From: <eddie.grant@exeloncorp.com>
To: <nvg@nrc.gov>
Date: 10/11/04 11:26AM
Subject: RE: Response to RAI Letter No. 4

Subject: Response to Request for Additional Information (RAI) Letter No. 4 –
Exelon Early Site Permit (ESP) Application for the Clinton ESP Site
(TAC No. MC1122)

Enclosure: Response to RAI 2.3.1-1 through 2.3.1-10 (and associated attachments)
Response to RAI 2.3.2-1 through 2.3.2-6
Response to RAI 2.3.3-2 through 2.3.3-4
Response to RAI 2.3.4-1 through 2.3.4-2 (and associated attachments)

Figure 23.4 The maximum wind speed expected at a probability level of 10^{-6} (once in 1,000,000 years). The isopleths for wind speed are after Fujita (1987), determined using UC data 1916-1985. The base map is of Project significant tornadoes, 1916-1989.

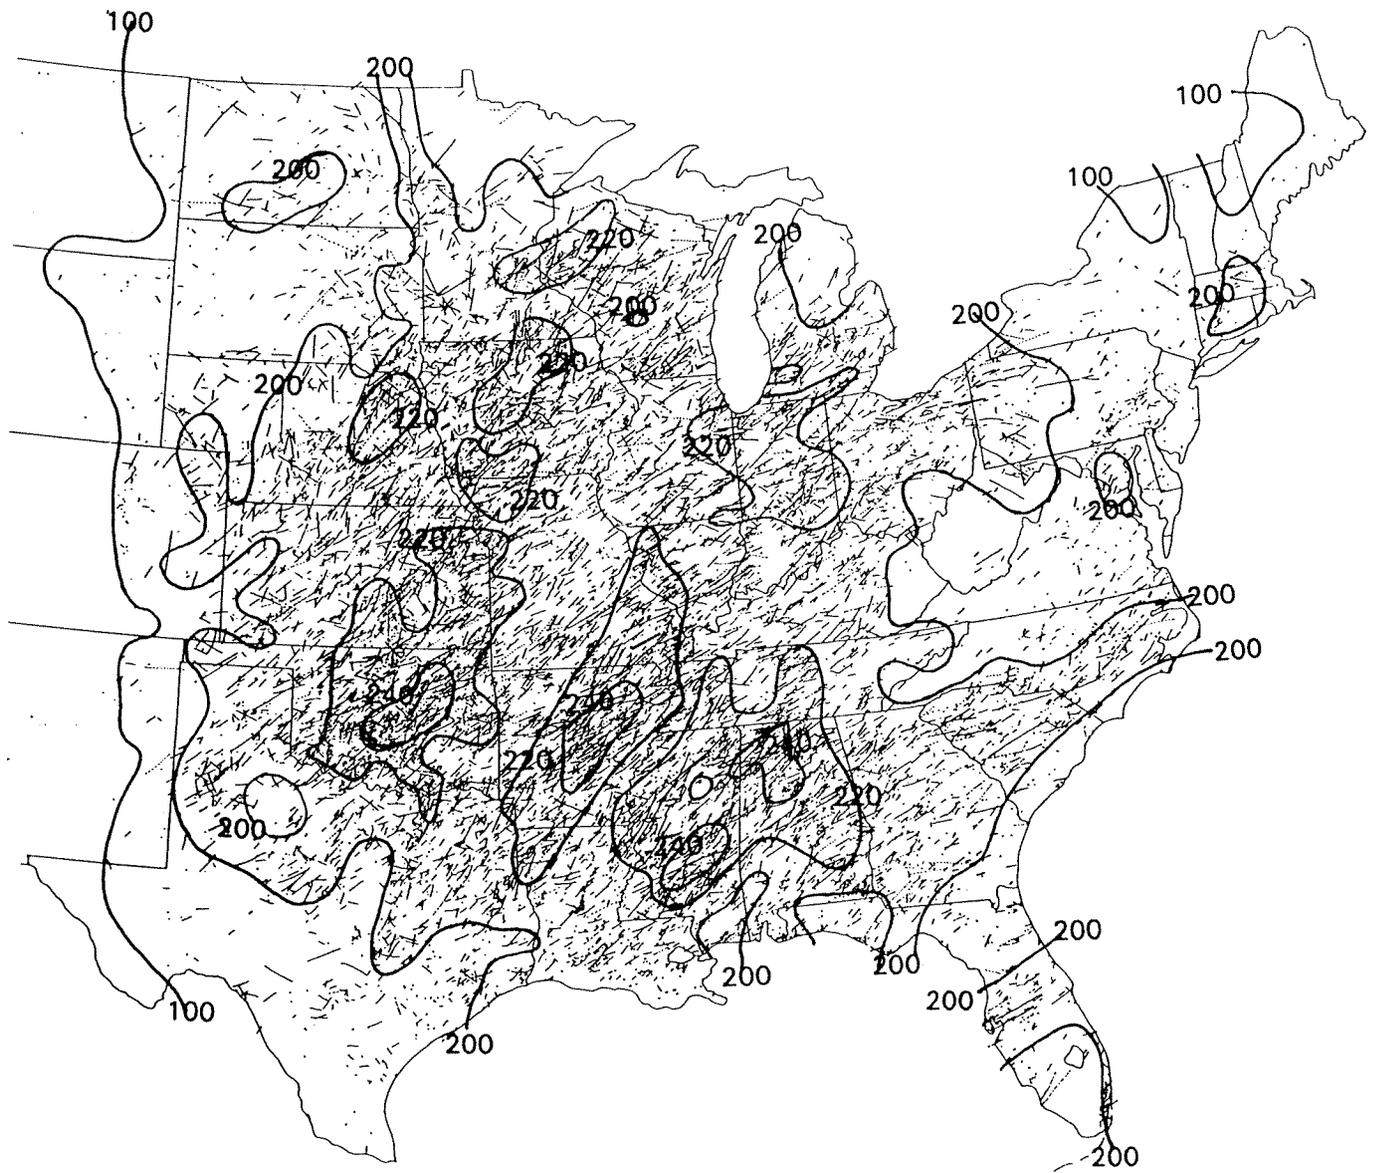
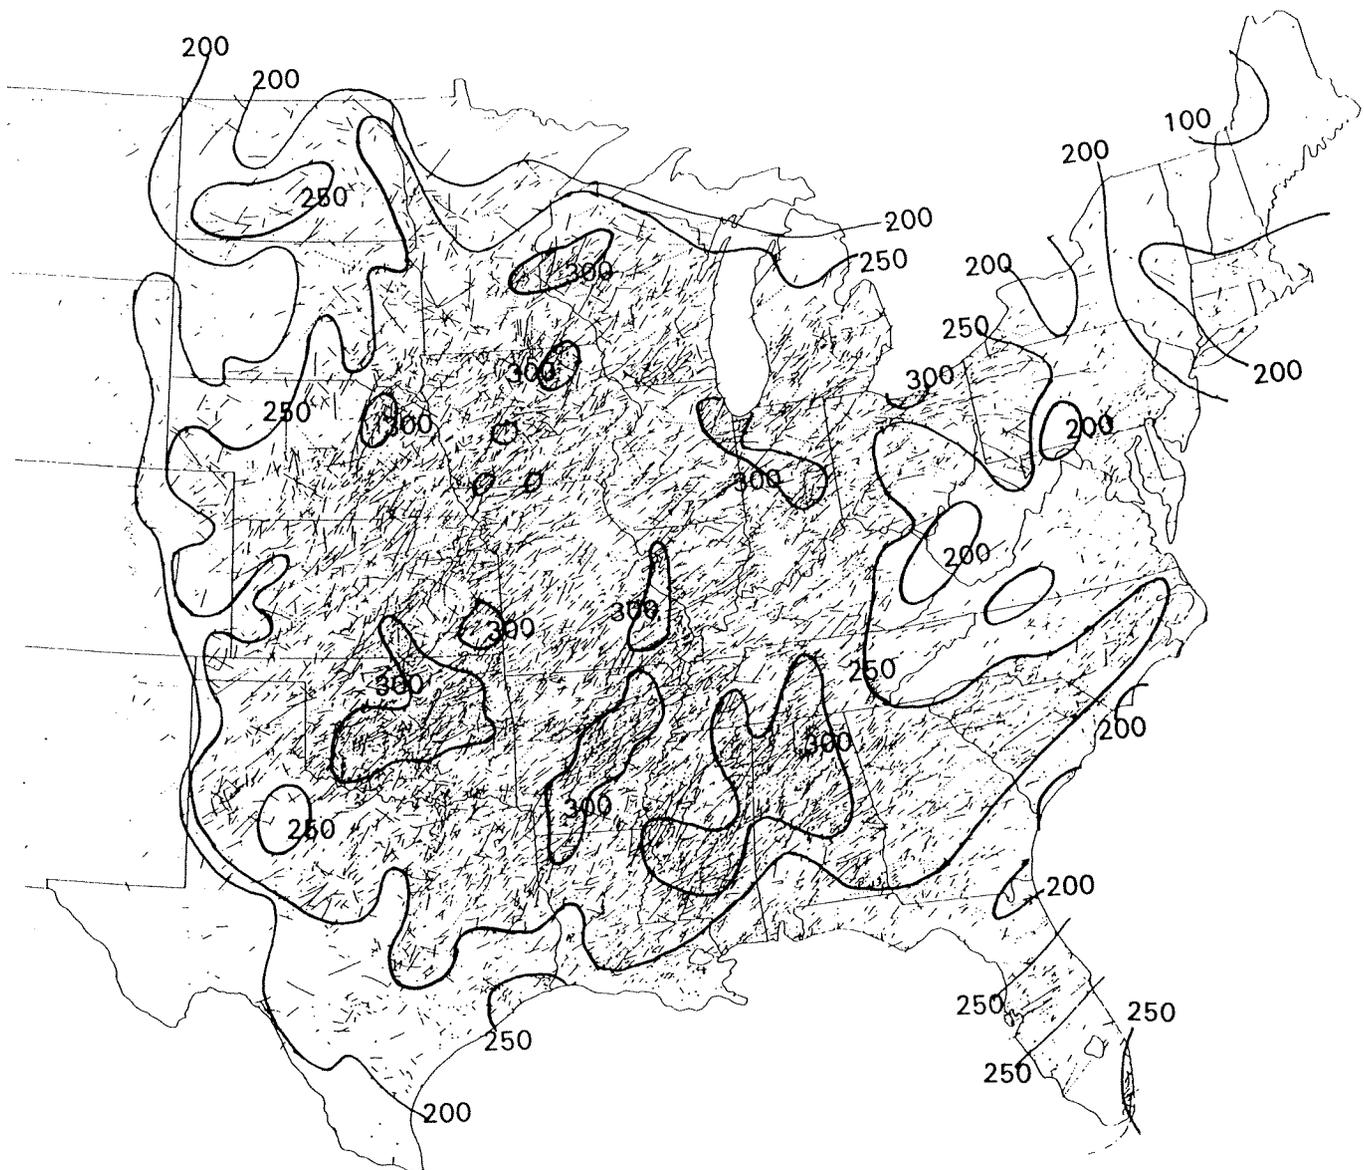
ESP applicants are not required to use either RG 1.76 or the staff's interim position on design basis tornado wind speed, although they may do so since both are staff-accepted approaches. ESP applicants may use any design-basis tornado wind speeds that are appropriately justified. However, the staff does not believe that citing SECY-93-087 (or any document related to design certification) is adequate justification for use of 300 mph. In particular, Figure 30 of NUREG/CR-4461 shows a 10^{-7} probability of occurrence of wind speed of 327 mph for the Clinton ESP site. Please provide a safety justification for choosing 300 mph as the site characteristic maximum tornado wind speed for the Clinton ESP site.

Additional justification for a site-specific 300 mph tornado wind speed site characteristic is provided in a 1993 published analysis of tornadoes (Grazulis, 1993) from 1680 through 1991 conducted by *The Tornado Project* headed by Thomas P. Grazulis. This analysis indicates that the maximum wind speed expected at a probability of $10E-6$ (i.e., once in 1,000,000 years) at the Clinton site will be between 200 and 220 mph (Figure 23.4 in Grazulis, 1993). This analysis also indicates the maximum wind speed expected at a probability of $10E-7$ (once in 10,000,000 years) at the Clinton site will be between 250 and 300 mph (Figure 23.5 in Grazulis, 1993). Thus, this data indicates a Clinton site characteristic of 300 mph or less even using the requested 10^{-7} recurrence interval. A copy of the referenced Figures is provided as an attachment to this response. This information and reference will be incorporated into the SSAR in a future revision.

These parameters are believed to be relatively consistent with expected conditions associated with potential worst-case tornadoes, namely the F4/F5 class of tornadoes. In addition, a site-specific 300-mph tornado wind speed site characteristic is consistent with a 1993 published analysis of tornadoes (Grazulis, 1993b) from 1680 through 1991 conducted by The Tornado Project headed by Thomas P. Grazulis. This analysis indicates that the maximum wind speed expected at a probability of $10E-6$ (i.e., once in 1,000,000 years) at the Clinton site to be between 200 and 220 mph (Figure 23.4 in Grazulis, 1993b). This analysis also indicates the maximum wind speed expected at a probability of $10E-7$ (once in 10,000,000 years) at the Clinton site to be between 250 and 300 mph (Figure 23.5 in Grazulis, 1993b). Thus, this data indicates a Clinton site characteristic of 300 mph or less even using a 10^{-7} recurrence interval.
